200 TO (HK) LTD.
 JOB #: 3482H1
 FCC ID : O4Y10038
 EXHIBIT : 2

TITLE:	10038(49.86MHZ)
P.C.B.	10038
DRAWN:	HO
DATE:	2001-03-28

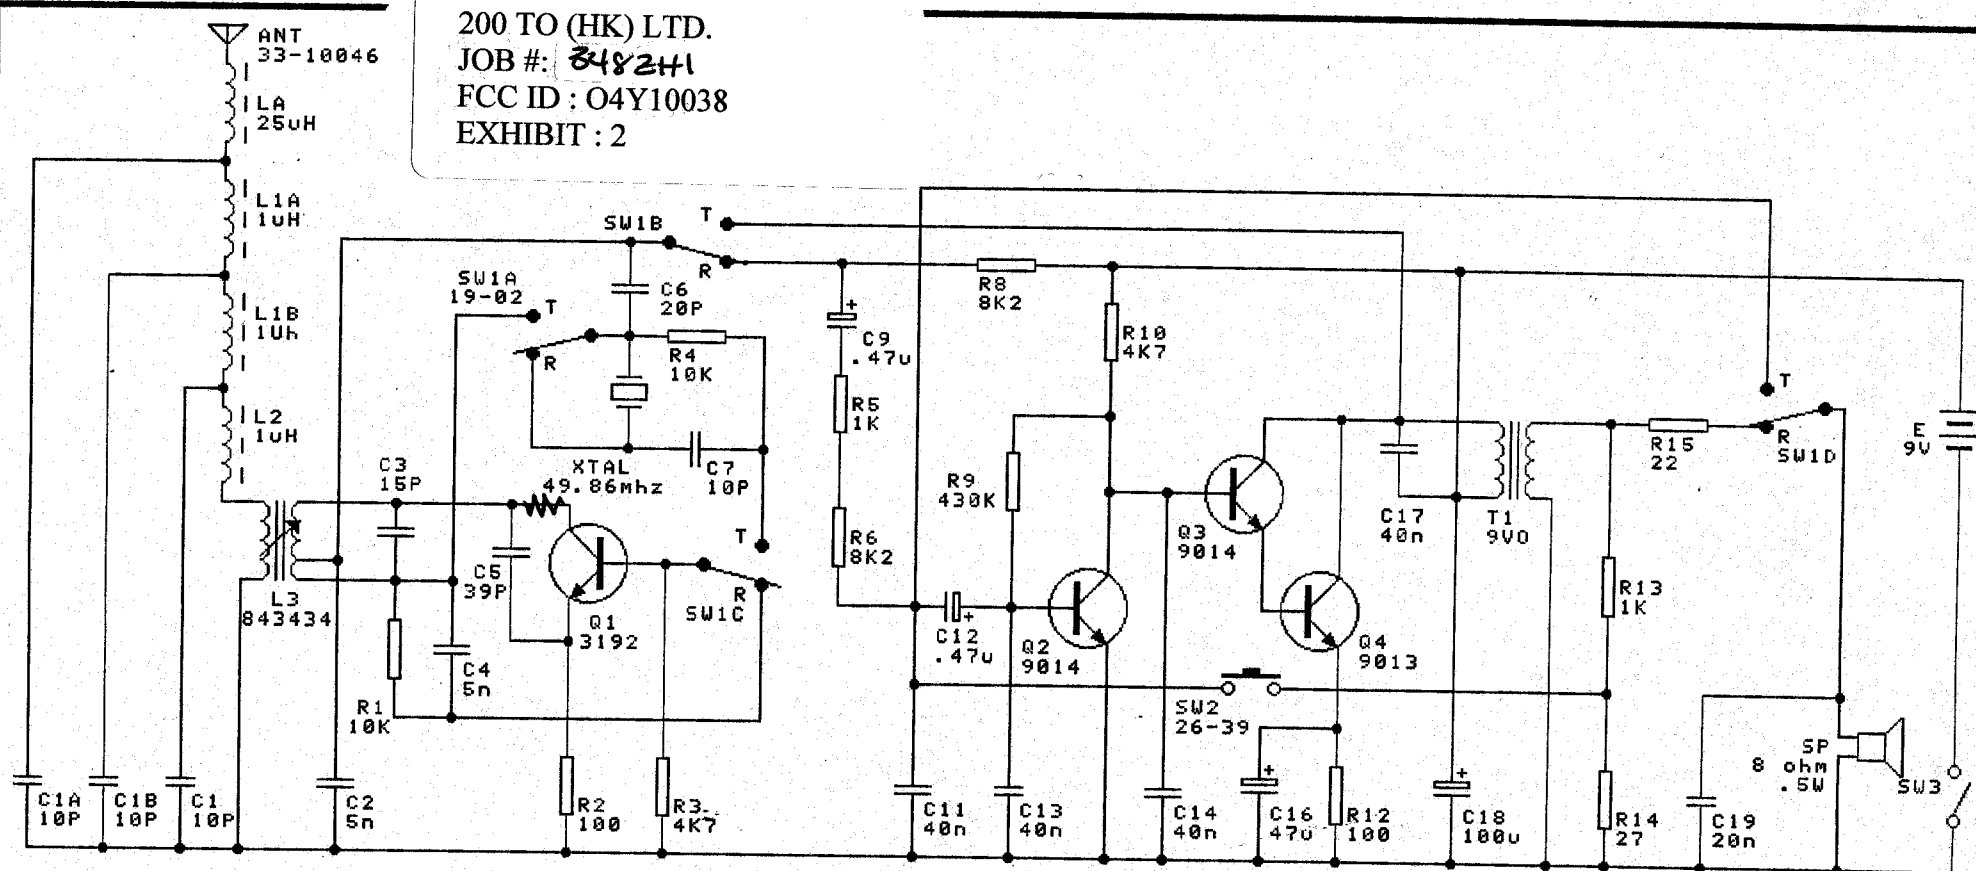
Add 56 Ω resistor in series with collector of Q1
